TO: Mercedes-Benz Dealer Principals, General Managers, Sales Managers, Service Managers, Parts Managers	FROM: Gregory Gunther, Department Manager, Vehicle Compliance and Analysis, Engineering Services
RE: Recall Campaign Launch Notification Check Sliding Roof Bonding MY01-11 C-Class, CLK-Class, E-Class and CLS-Class (203, 209, 211 and 219 platform)	DATE: January 20, 2023

Recall Campaign Bulletin

Campaign No. 2023010004, January 2023

Check Sliding Roof Bonding

Figure 1

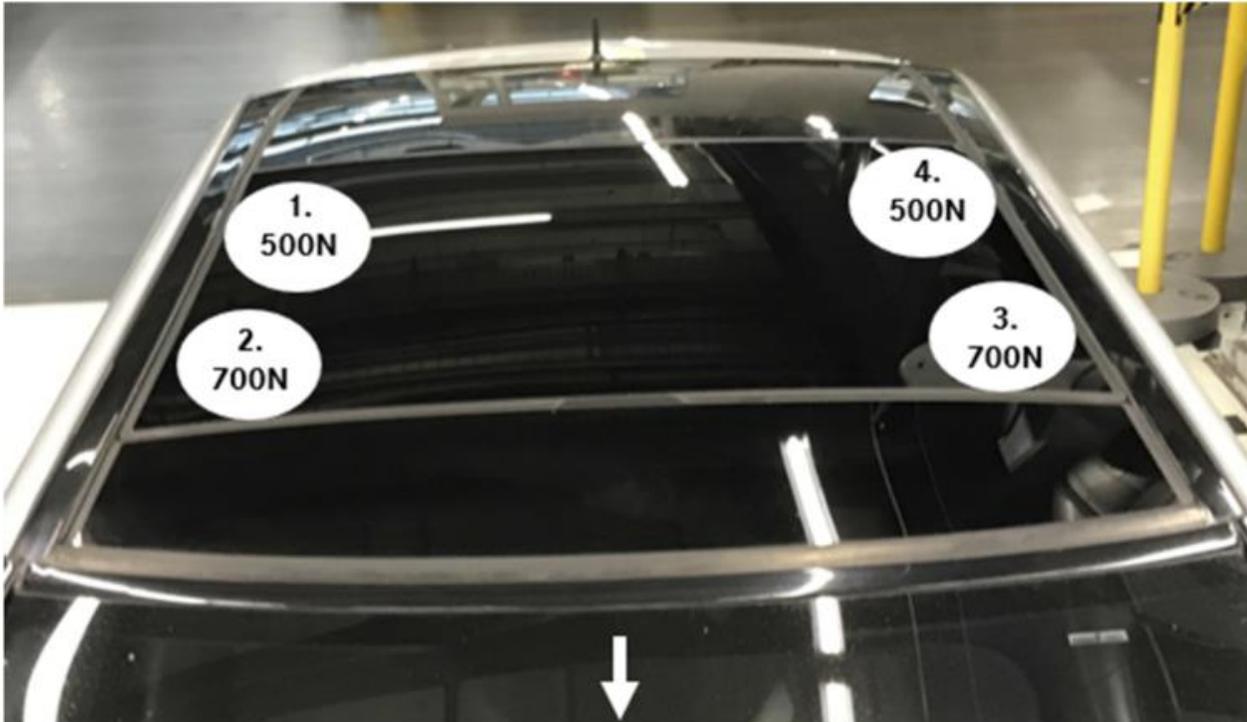
3. Position suction cup tool (figure 1) and pull up as **vertically** as possible (tolerance of ± 10 degrees) using lifting tool.

i Specified force **500N / 700N** (Figure 2).

i Position suction cup tool at 4 points in the sequence **1, 2, 3, 4**: (Figure 2).
